Intel Technical Advisory

TA-1054-01

Incorrectly wired SATA power cables on the Intel® Server System P4000 Family and the Intel® Server Chassis P4000 Family

Figure 1. Location of the date code "P/N DD0S6CPB700 12/15/2013"

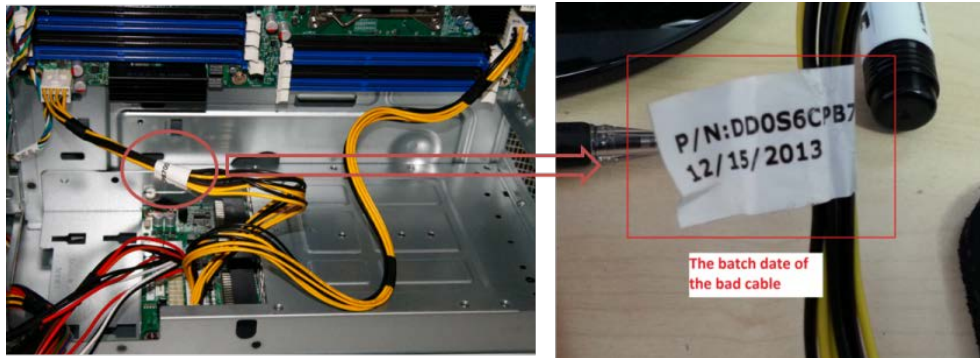
It has been confirmed that the issue happens only with a certain date code "P/N DD0S6CPB700 12/15/2013" of the power cable that connects to the 2x12 pin connector (labeled "Main PWR1") on the PDB. Customers can identify the date code by locating the label shown in Figure 1.

Intel will provide the correct power cable to customers as a replacement upon request. Please contact Intel using your normal warranty process to obtain the cable. Please indicate you are calling regarding TA-1054-01 for a replacement cable with the part number DD0S6CPB700 and have the following information when you call: serial number(s) for the system(s) or chassis.

Figure 3. Pin connection of the two SATA 1x5 pin Peripheral Power Connectors (labeled P5 and P6)

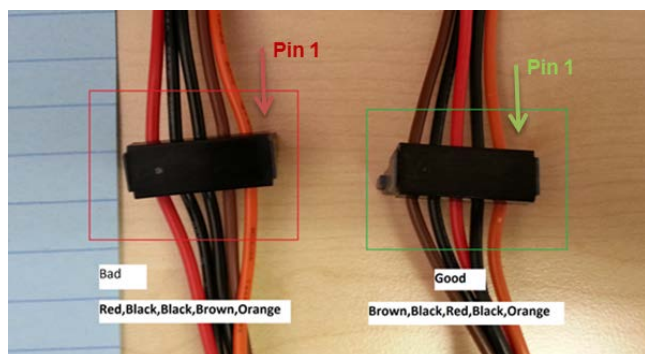
Intel has determined that this failure is due to the incorrectly wired pin connection on the two SATA 1x5 pin Peripheral Power Connectors (labeled P5 and P6). The correct pin definition of the connector should be Orange, Black, Red, Black, and Brown from Pin 1 while the problematic connectors are wired in a different order as Orange, Brown, Black, Black, and Red from Pin 1.

Intel has screened the current inventory to ensure systems and chassis are shipped with the correct SATA power connectors.
